## **Re: Nolans Project, request for further information**

On 20 June the NT EPA received a notification of alterations to the Nolans Project in accordance with clause 14A of the Environmental Assessment Administrative Procedures. Officers of DENR in consultation with Northern Territory Government advisory agencies reviewed the Notification, and their review has sought additional information. Outlined below is the required information, to enable the NT EPA to decide whether the alterations to the Nolans Project requires further assessment or conditions under the Environmental Assessment Act 1982.

Typical terrain Reynolds Range

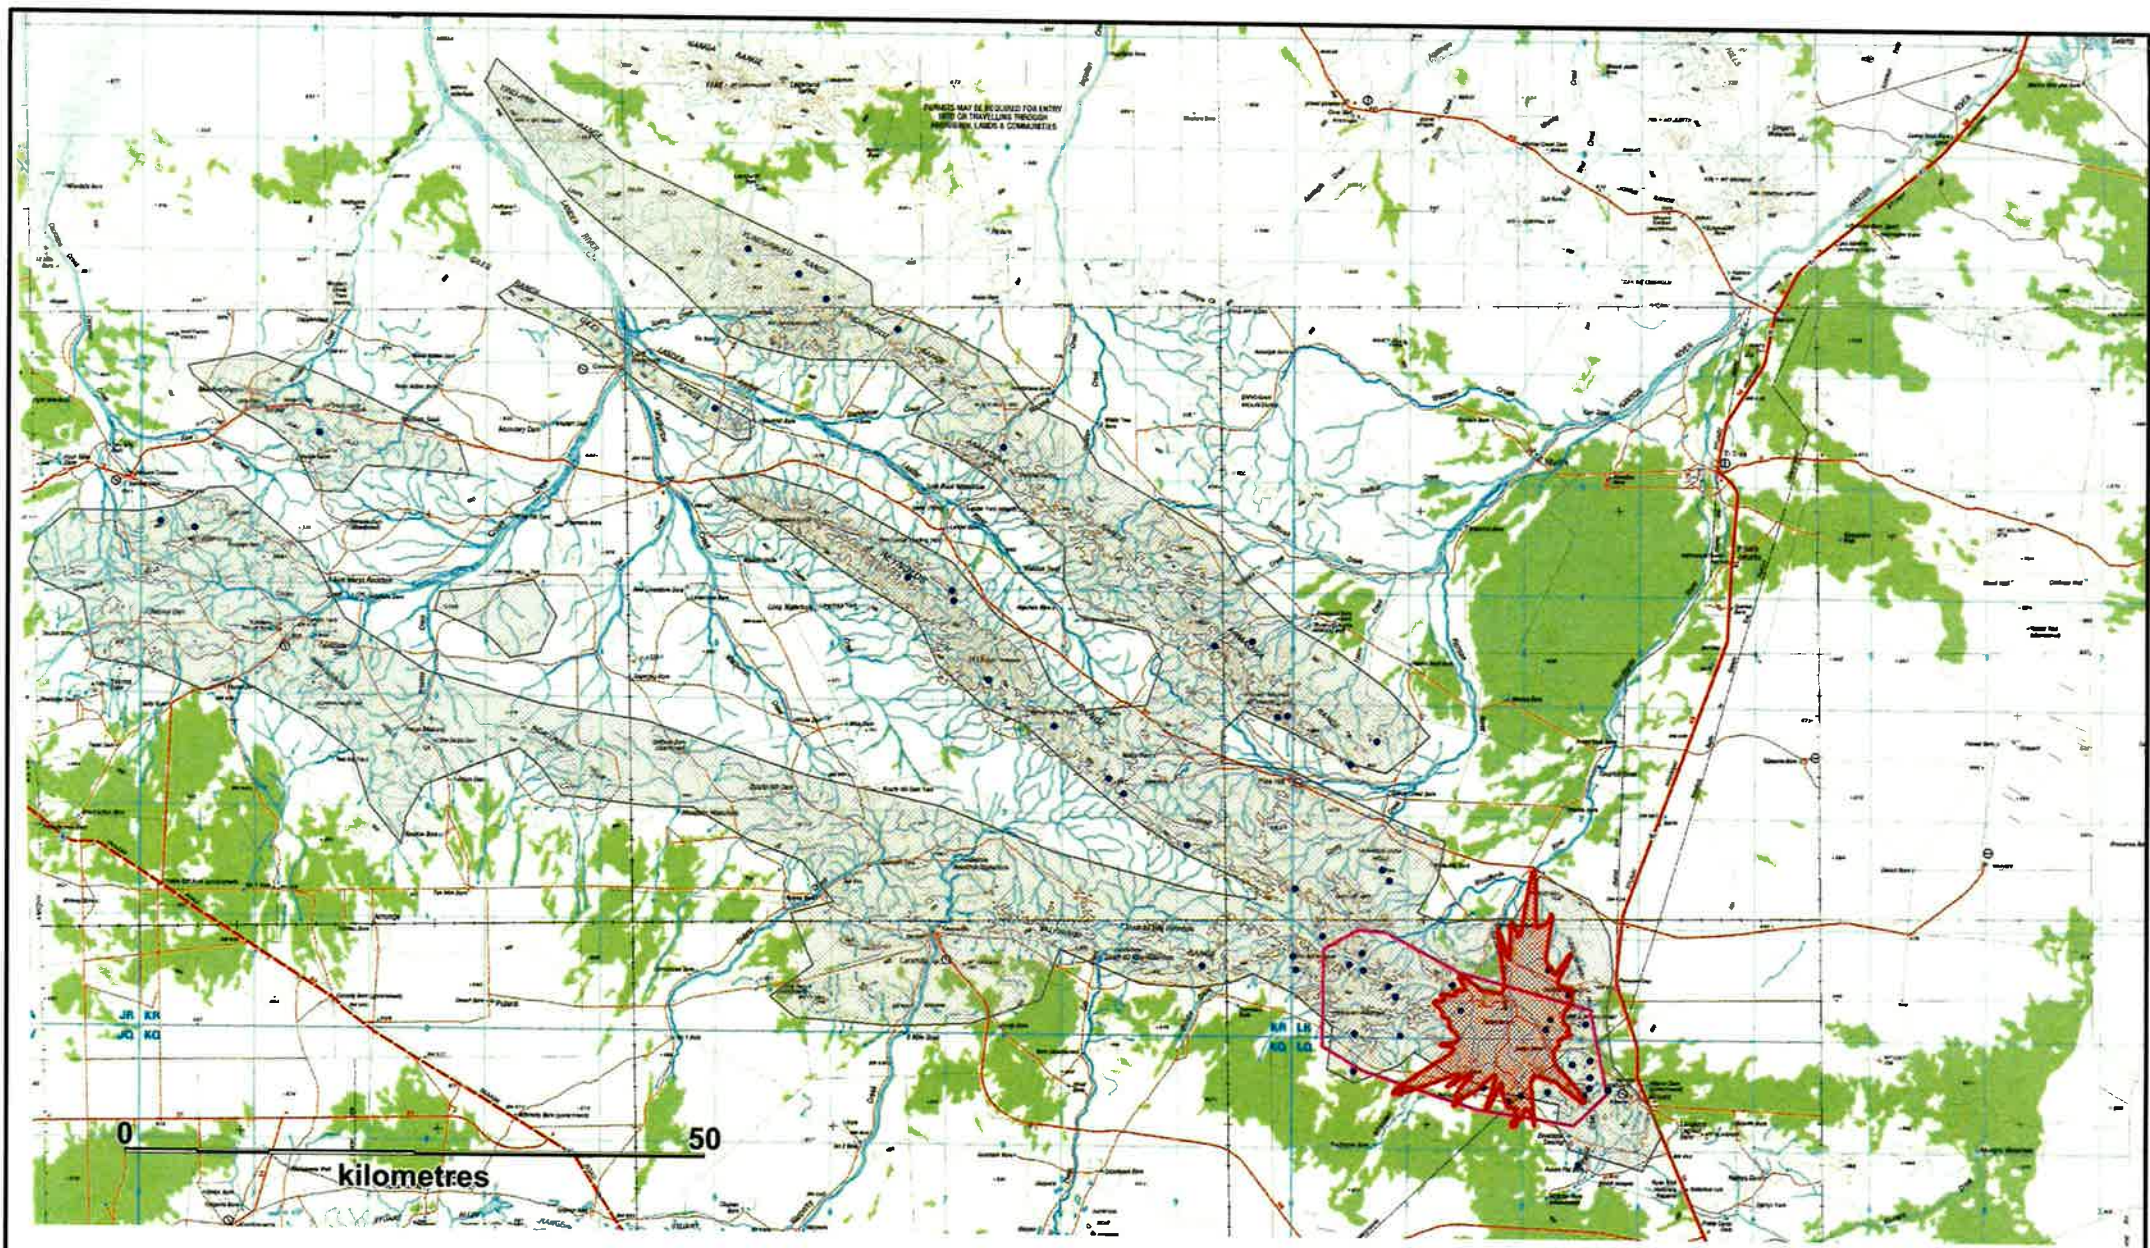
- DENR's assertion that inadequate survey effort was applied is refuted. The terrain encountered and present in the study area and regionally, exceeds over 3000sq kms is rugged and inaccessible other than on foot. The study area assessed represented a significant portion of this potential habitat. Because of the nature of the terrain and generally the poor accessibility, Arafura used a helicopter to fly the 3 study teams to the 65 selected study locations near the project area to conduct the survey assessments, at a significant cost. There were no responses from DENR on the adequacy of the surveys completed in either the Draft EIS or the Supplementary EIS document.
